Fire Department Station 3

Town of Sudbury ADA Transition Plan

October 2020

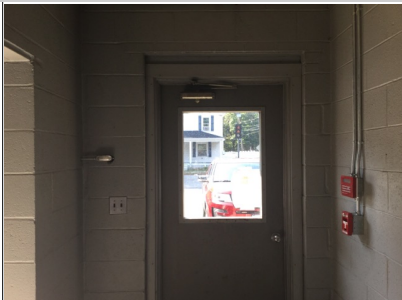
- There is a change in level greater than allowed on the exterior route to the main entrance.
